WATERLOO METRO QUARTER DEVELOPMENT

Site Plan

RTS Changes

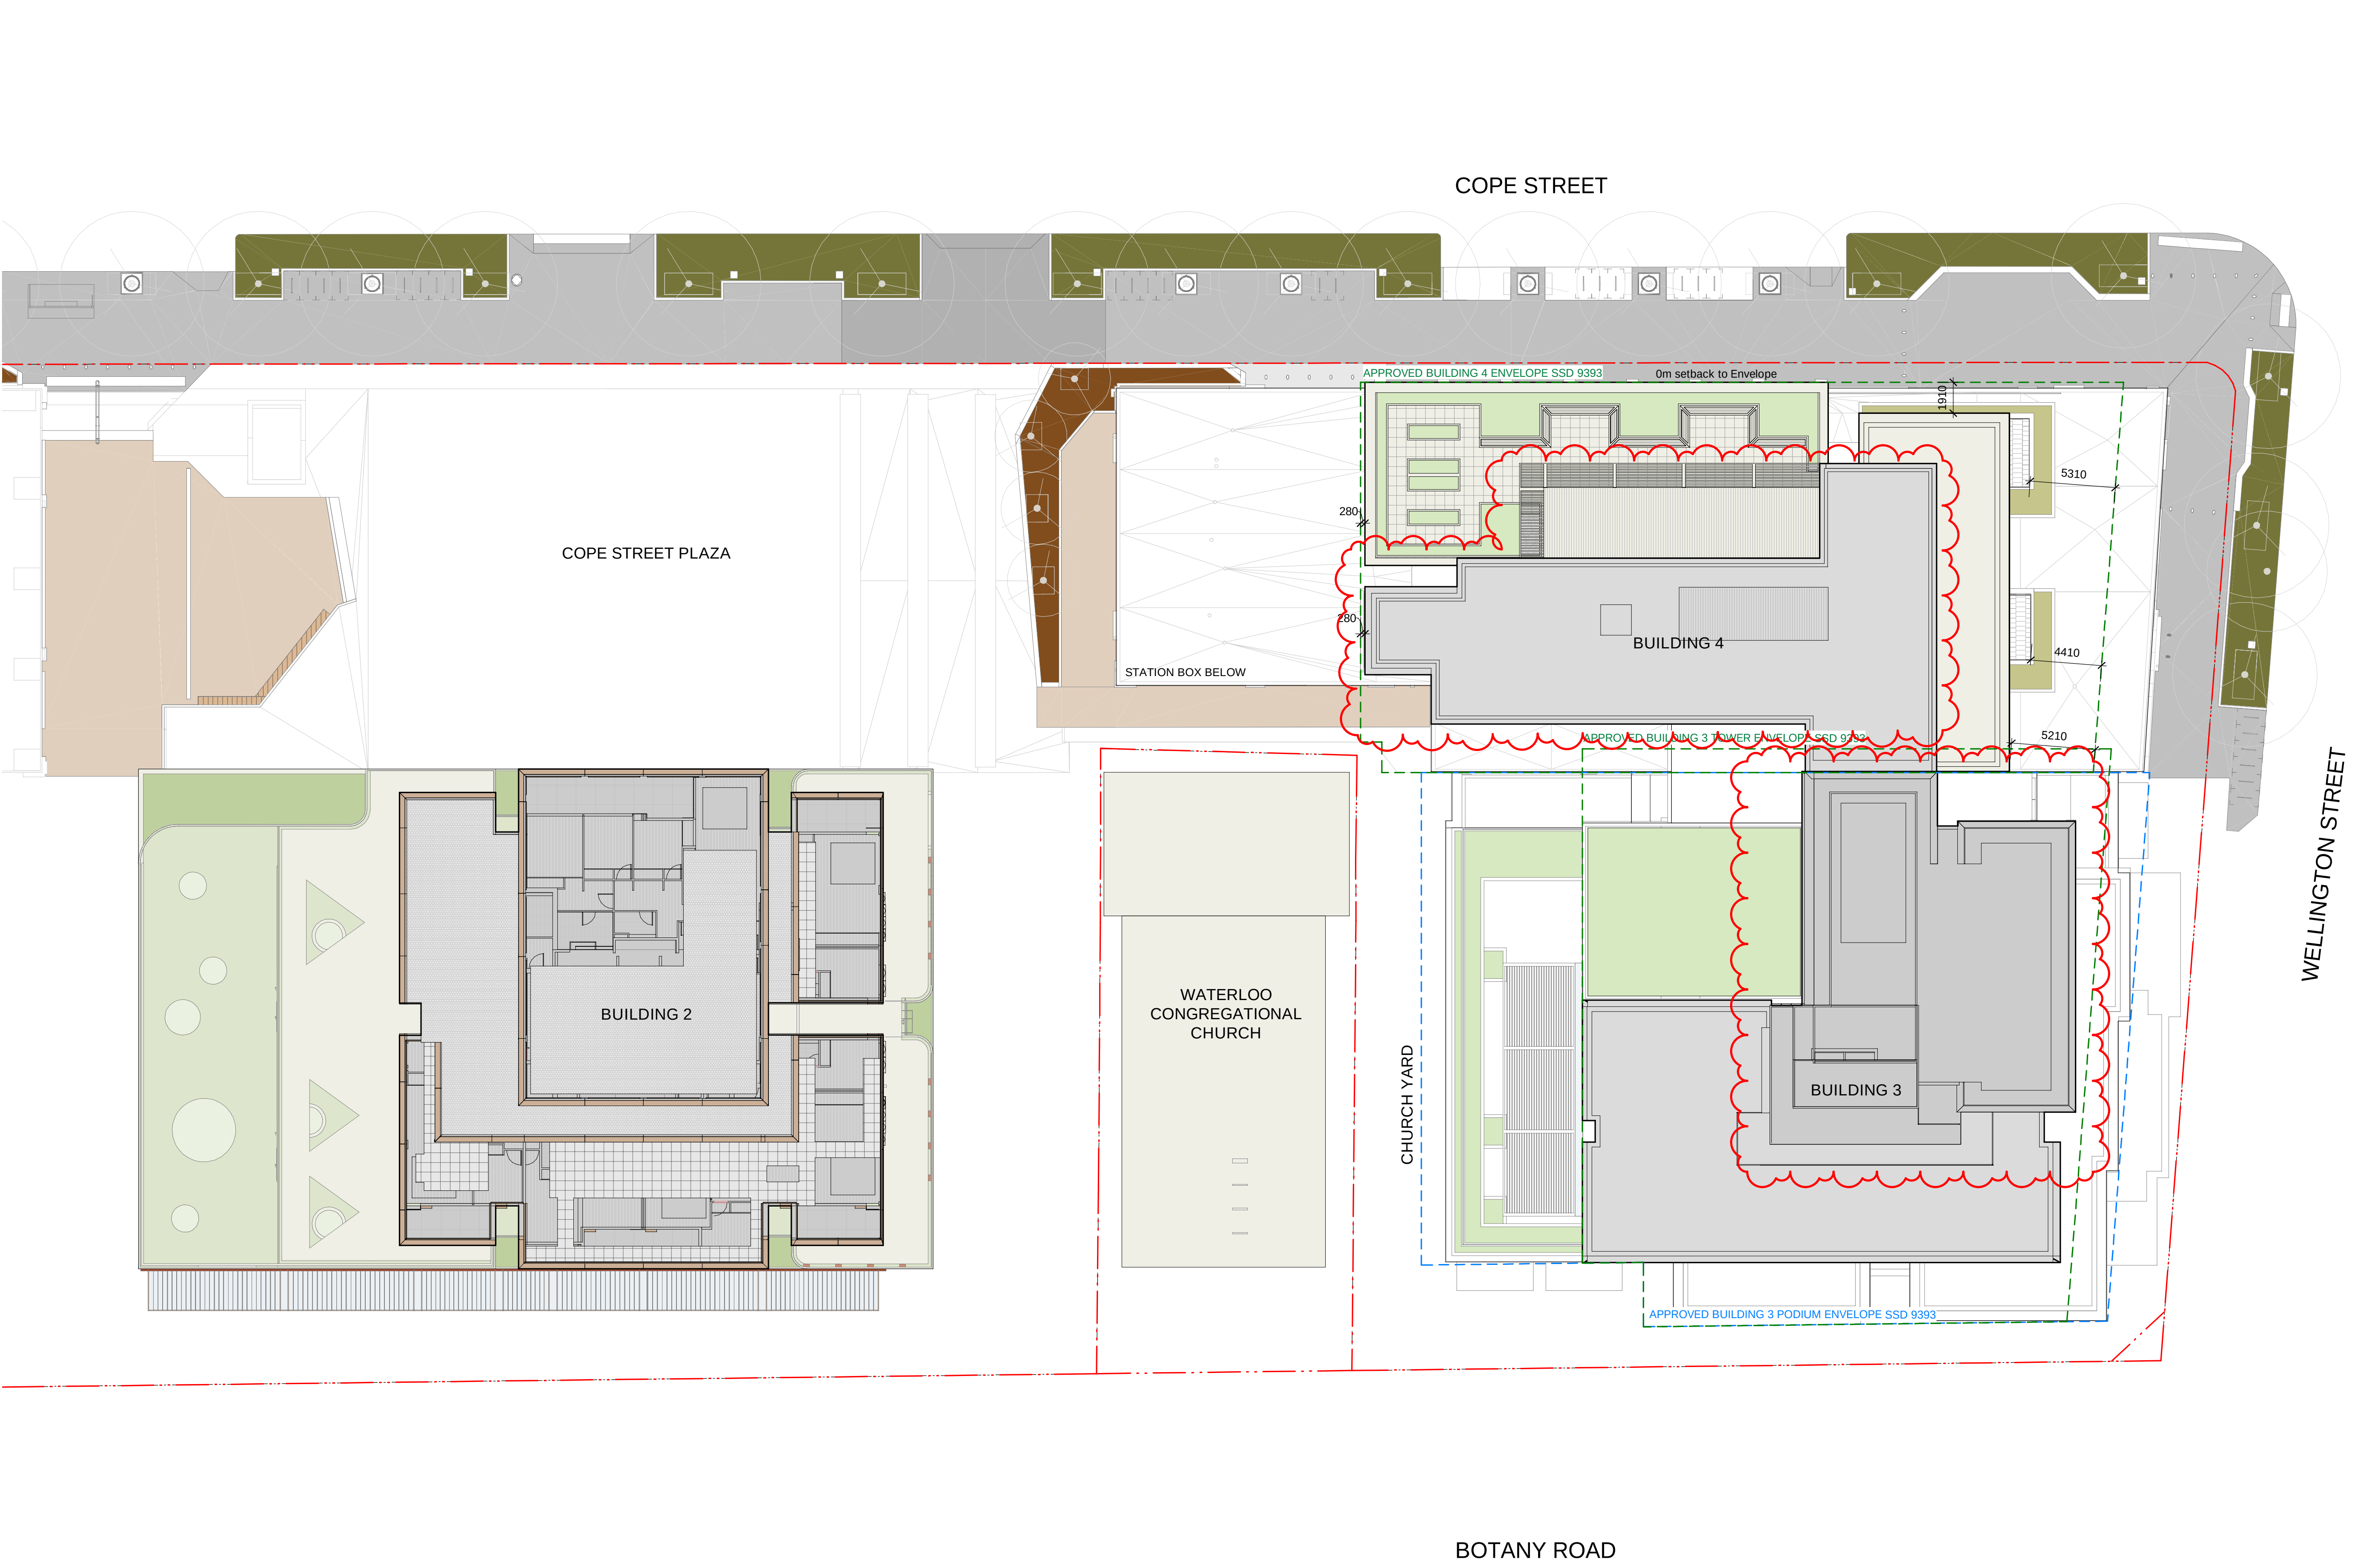
- RTS Changes
- Building 4 Parapet
 - Building 4 Roof Plant Enclosure
 - Building 4 Terrace Pergola
 - Building 3 Roof Plant Reconfiguration

Sheet title
General Arrangement Plan
Ground Floor Plan

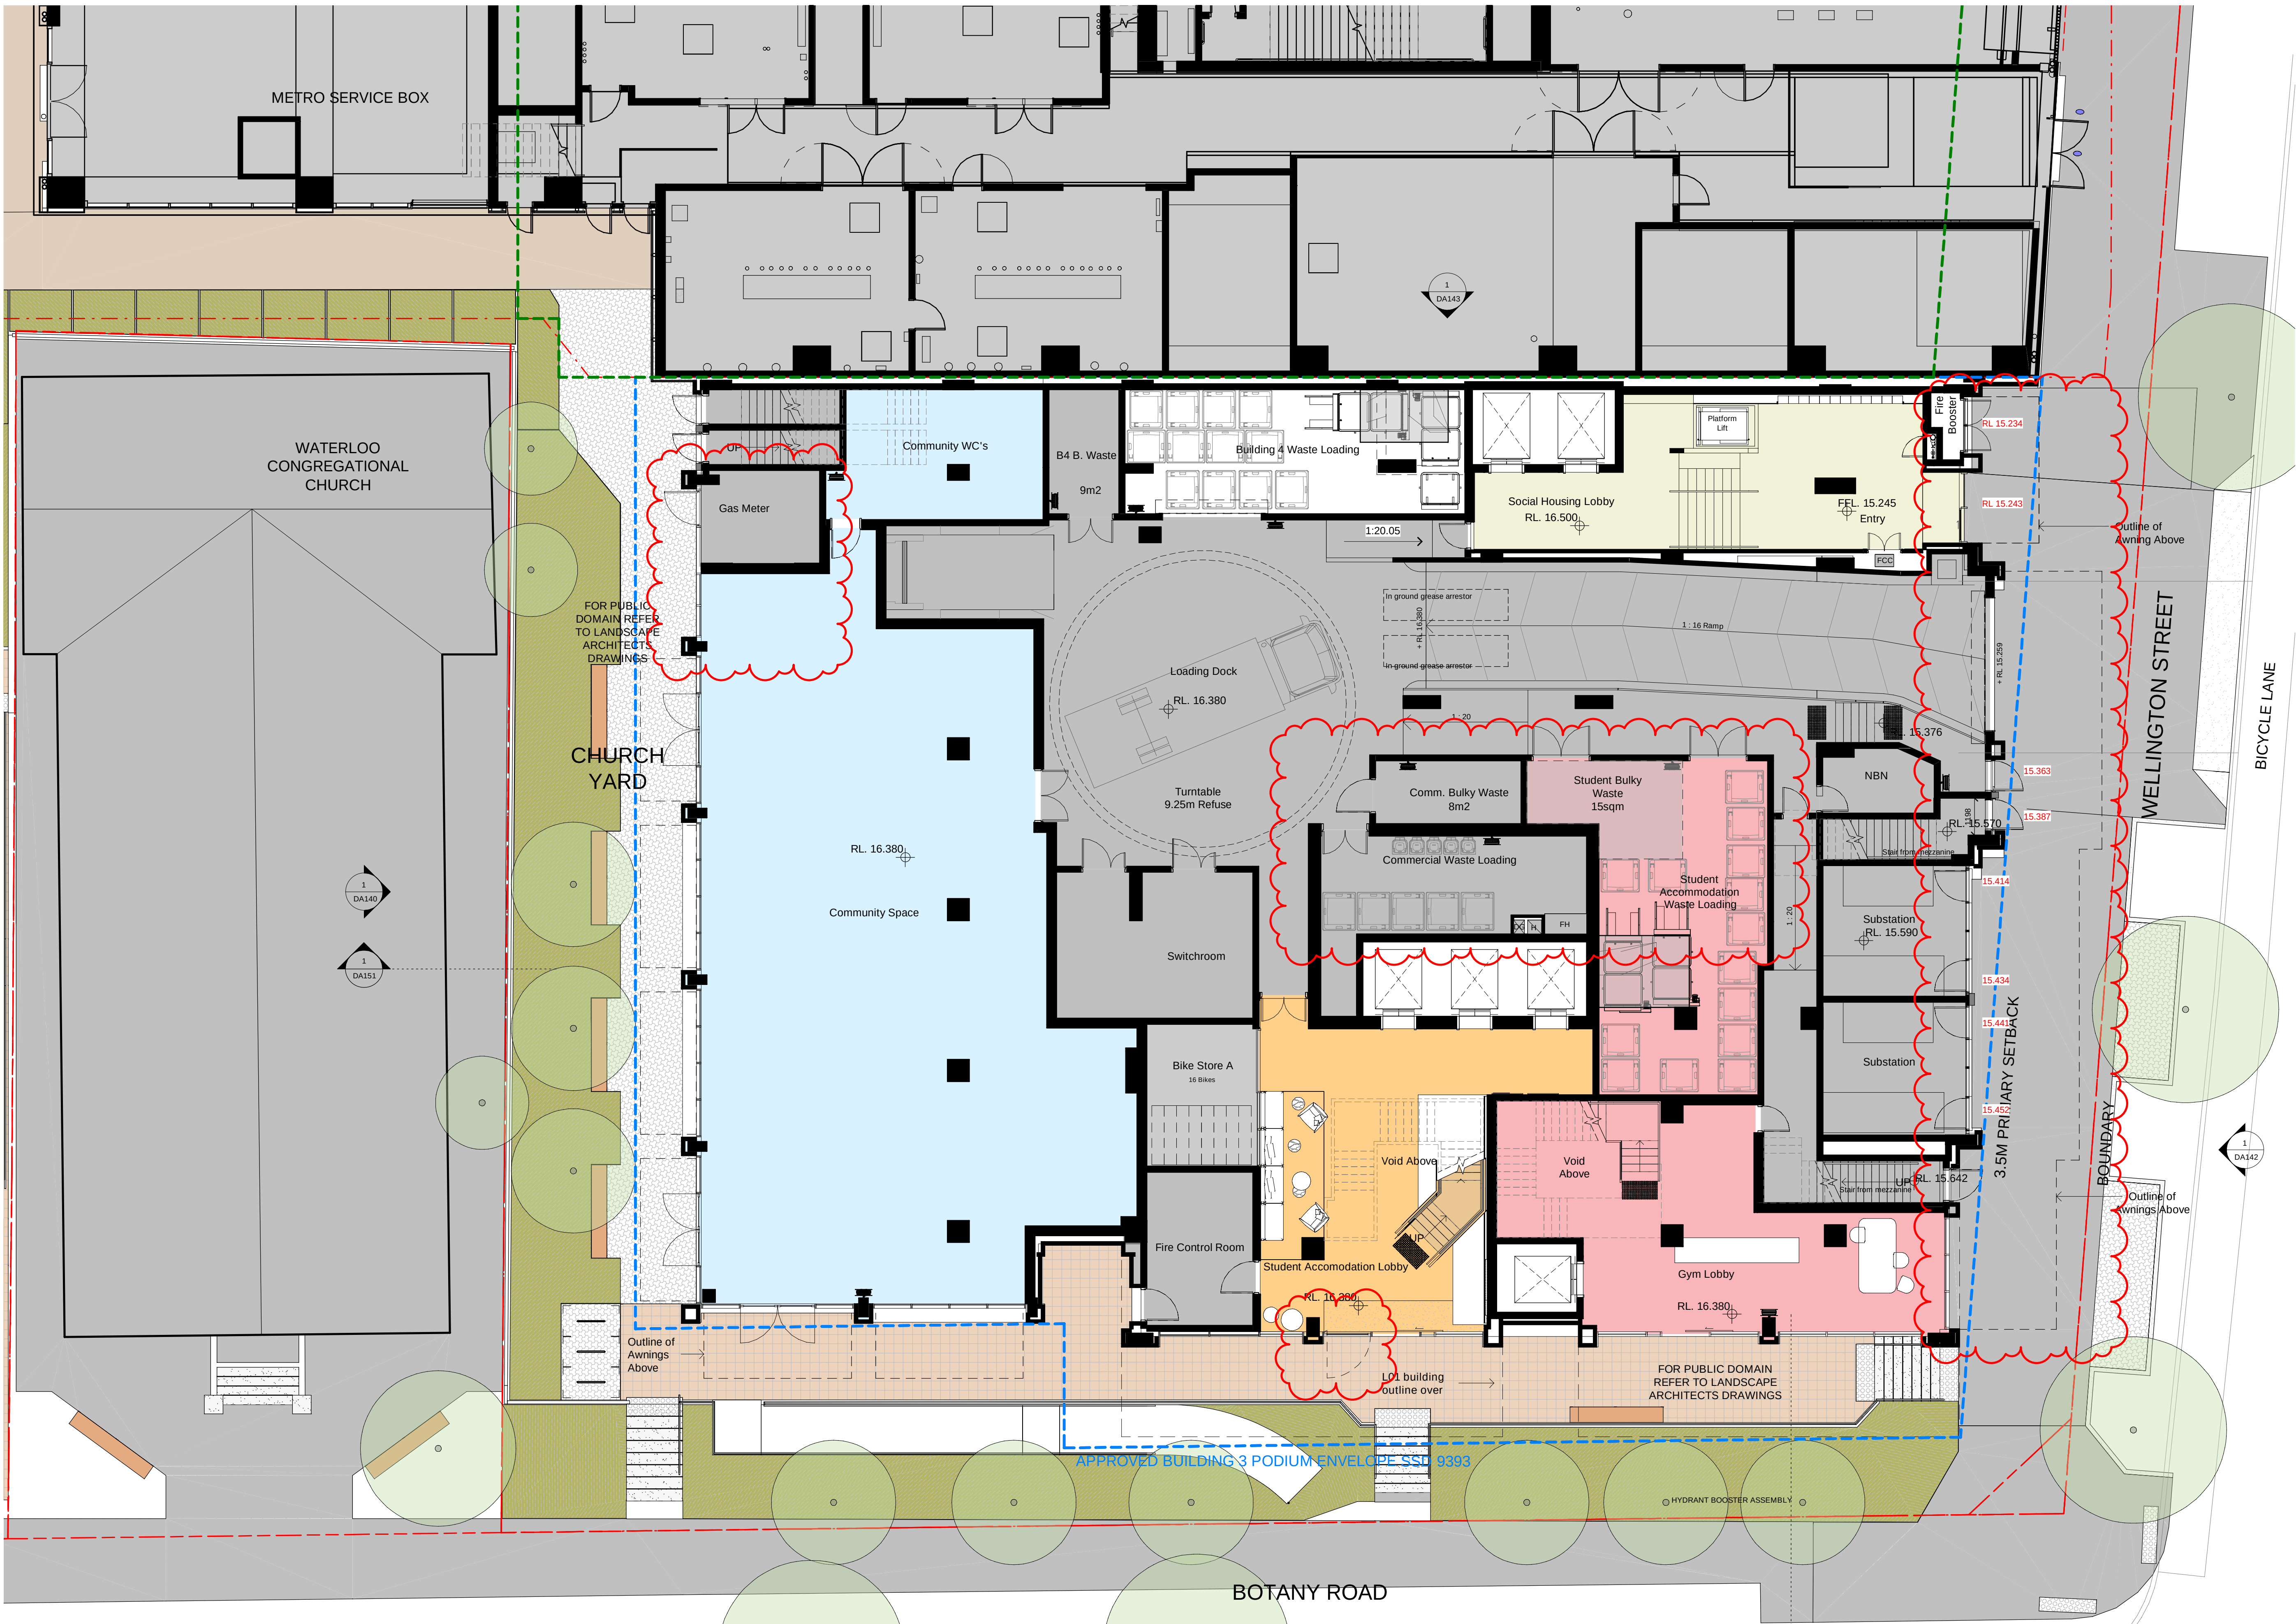
- Bulky Waste Area Reconfiguration
- Door Removed from Community Space
- Gas Meter Room Reconfiguration
- Addition of Swing Door in Student Accommodation Lobby
- Change to Social Housing Lobby Facade and Awning
- Change to Podium Southern Facade and Awning

Sheet title
General Arrangement Plan
Mezzanine Plan

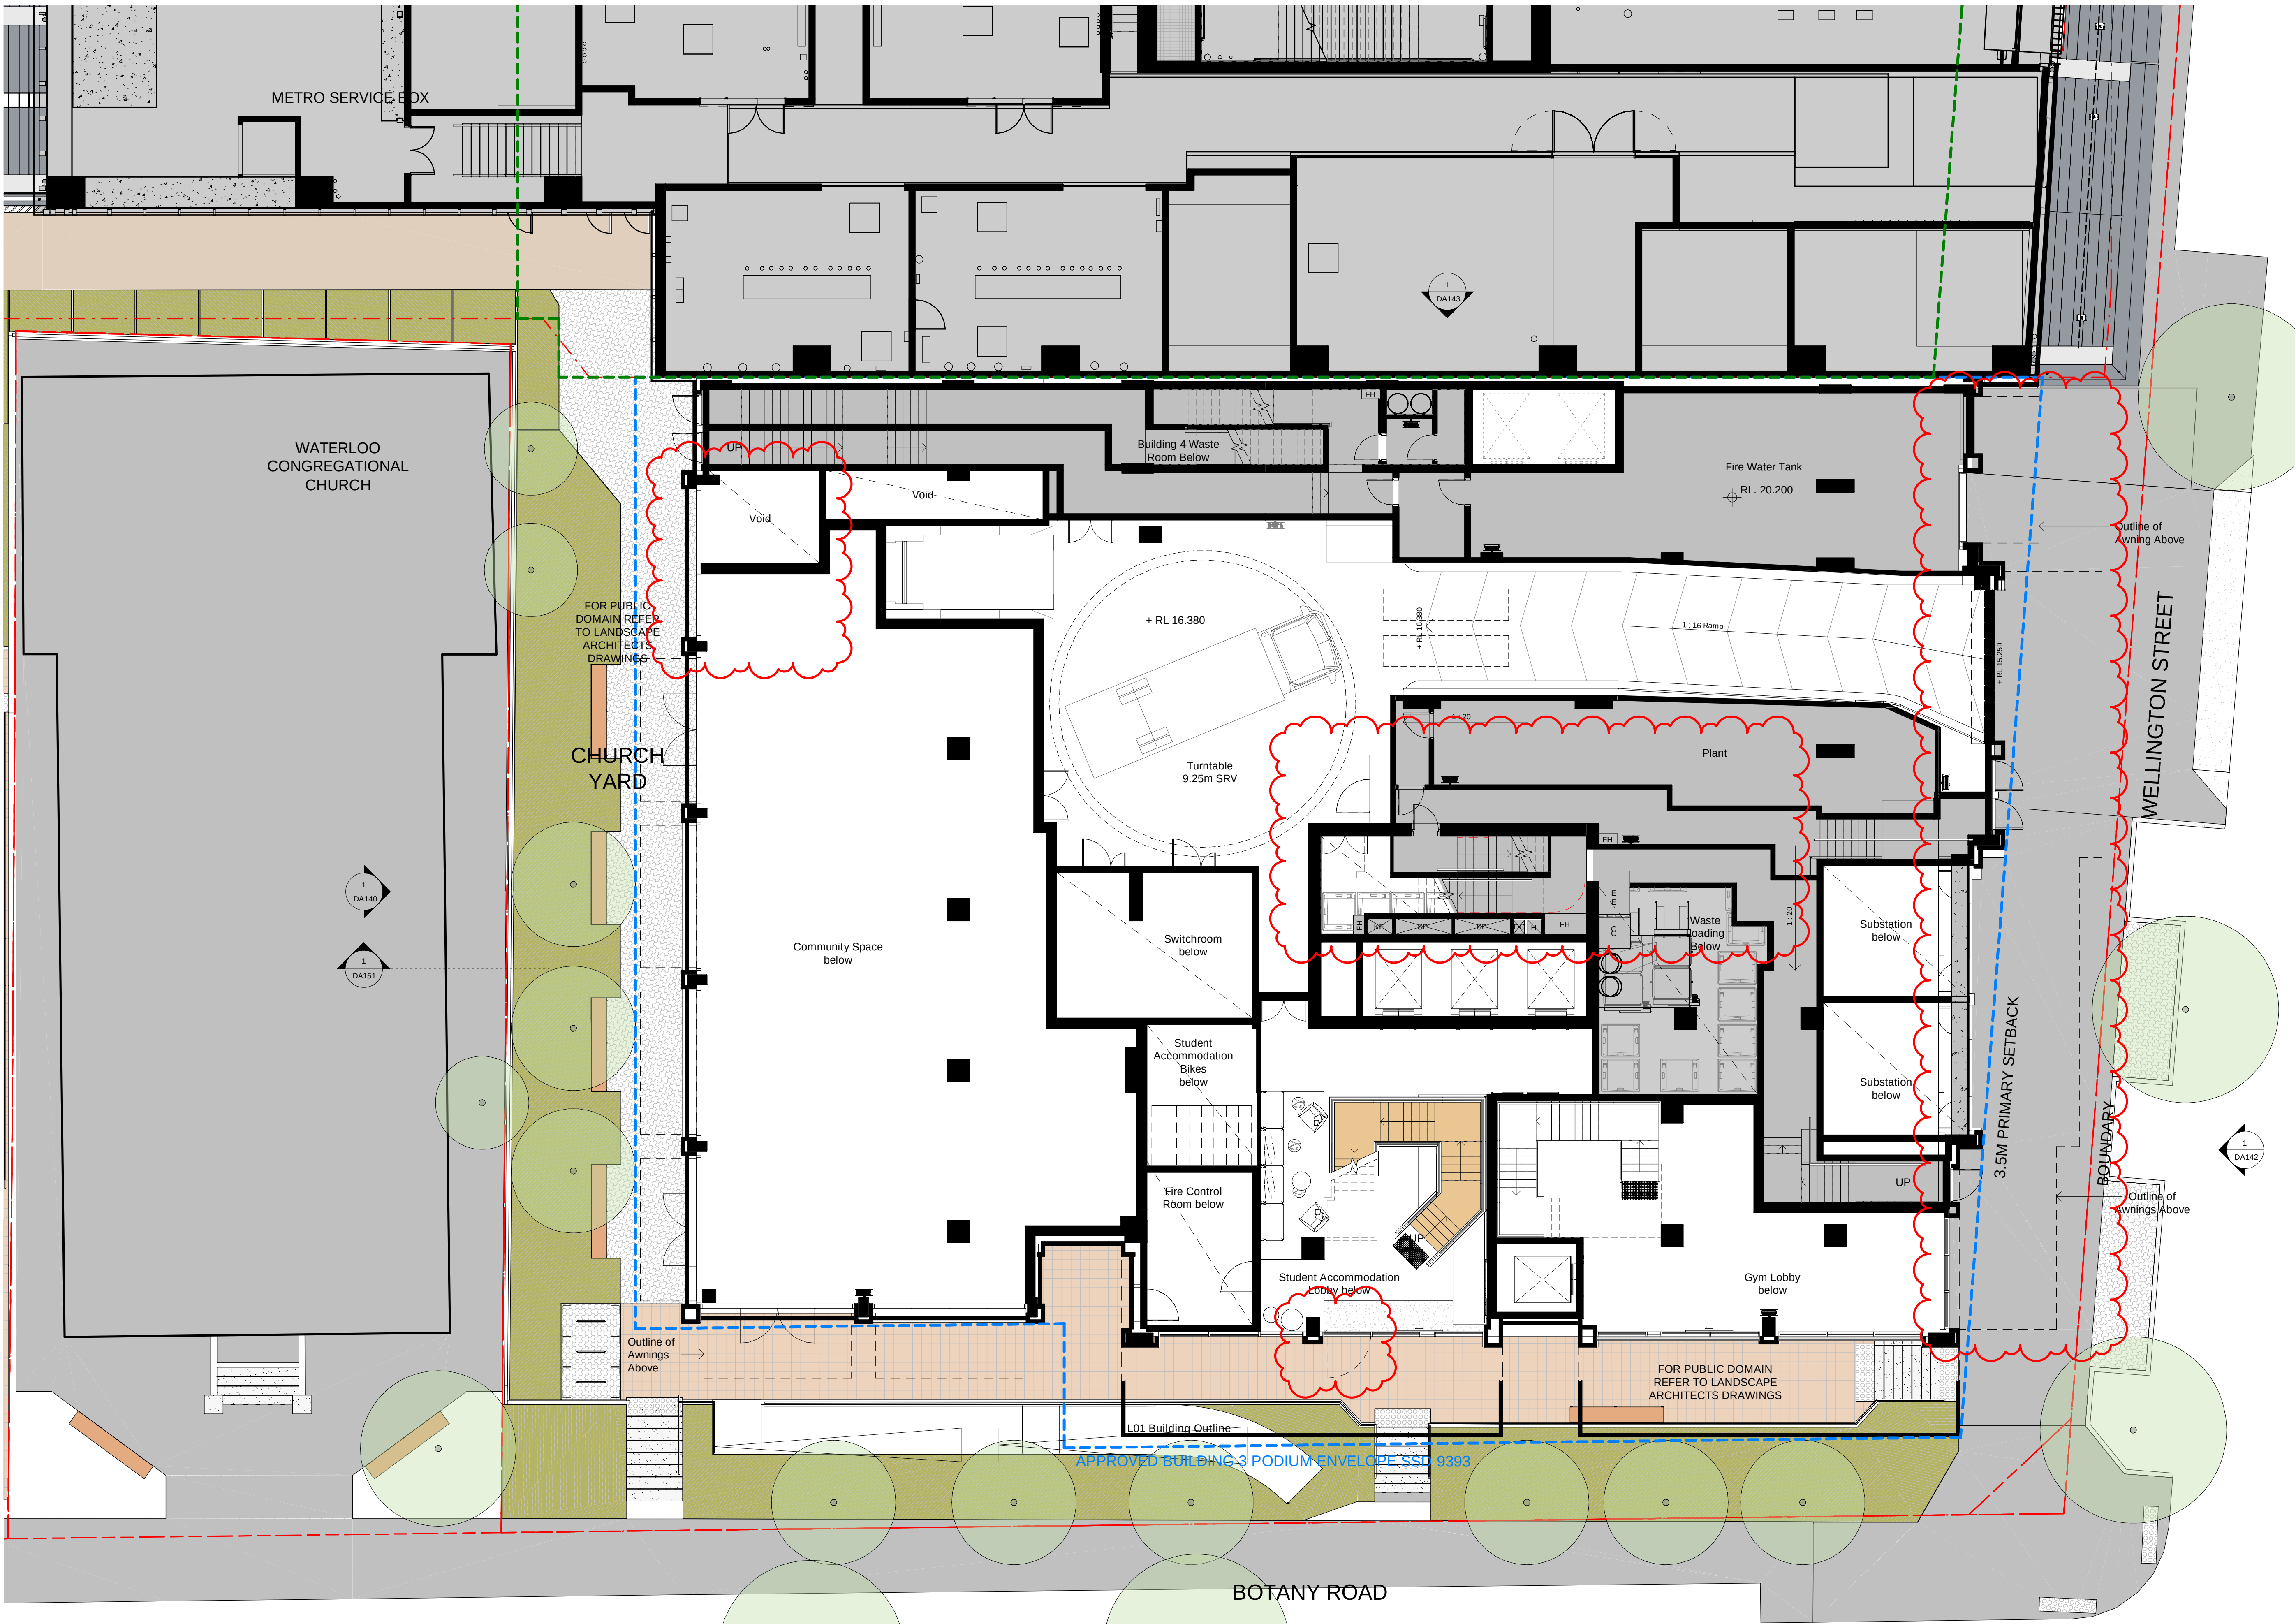
- Bulky Waste Area Reconfiguration
- Door Removed from Community Space
- Gas Meter Room Reconfiguration
- Addition of Swing Door in Student Accommodation Lobby
- Change to Social Housing Lobby Facade and Awning
- Change to Podium Southern Facade and Awning
